N8300A-03

S E R V I C E N O T E

N8300A Wireless Networking Test Set

Batch Related Component Issue May Result In A Non-Functioning Instrument

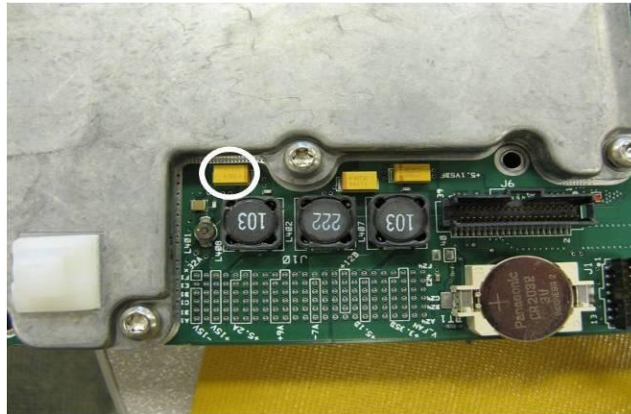
- (c) If the Source Assembly serial number falls within the range of 23080500002 to 23081200228 then proceed to (f).
- (d) If the Source Assembly serial number does not match the serial numbers listed, then use a permanent marker to place a black dot on the serial tag as depicted in Step 1. Doing so will assist in future quick recognition that a specific unit has been inspected or repaired.
- (e) Re-fit the external cover to the instrument, and power it on to ensure it is functioning without displaying any errors.
 - If any errors are present, then the instrument has a fault that is unrelated to this Service Note.
 - If the instrument has no errors, then it can be returned to the customer; adjustment is not required.
- (f) Carefully remove the Source Assembly from the instrument.
- (g) Inspect **C408** (10uF, 0180-4536) on the Top Side of the Source Assembly for lot code **712H2**:

- (i) If parts are found with lot code **712H2**, replace the part with part number 0180-4536. Refer to the **Removing and Replacing Parts** section for soldering instructions.
- (j) If neither of the capacitors have lot code 712H2, or after the suspect capacitor(s) are replaced, re-assemble the N8300A.

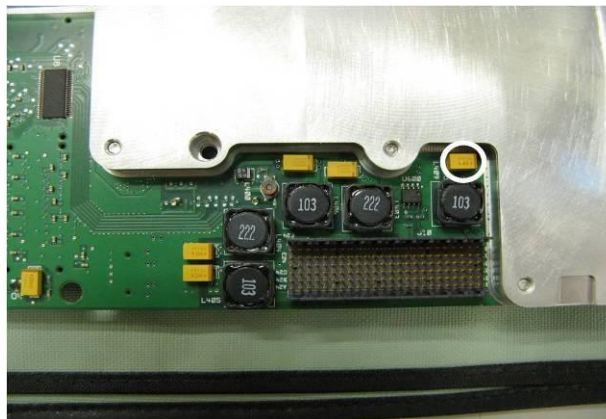
- (h) Inspect **C409** (10uF, 0180-4536) on the Bottom Side of the Source Assembly for lot code **712H2**:
